STONE AND WEBSTER MICHIGAN, INC.  
P.O. BOX 1963, MIDLAND, MICHIGAN 48640

DATE	2-2-84
J. O. NO.	14509
P. O. NO.	N/A
LTR. NO.	SWOC-84-023
REF.	N/A

STONE AND WEBSTER ENGINEERING CORPORATION  
NONCONFORMANCE IDENTIFICATION REPORT

Review of Electrical FCRs and FCNs/Document Control

E N° 1052

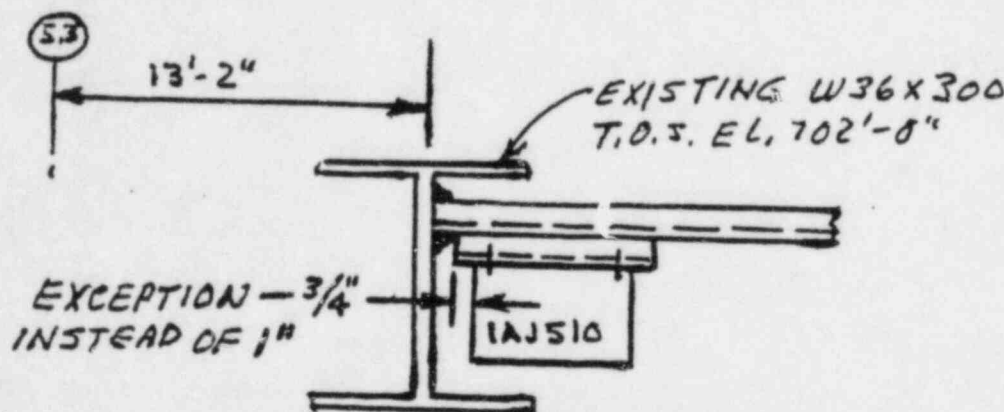
REASON FOR CHANGE

SPACE LIMITATIONS

EXISTING CONDITION

BOX 1AJS10 REQUIRES A SUPPORT

DESCRIPTION OF CHANGE

TYPE 22 JUNCTION BOX SUPPORT WITH  
EXCEPTION AS SHOWNEL. LOOKING NORTH, 2 FEET  
NORTH OF K LINE

NO DRAWING INCORPORATION REQUIRED
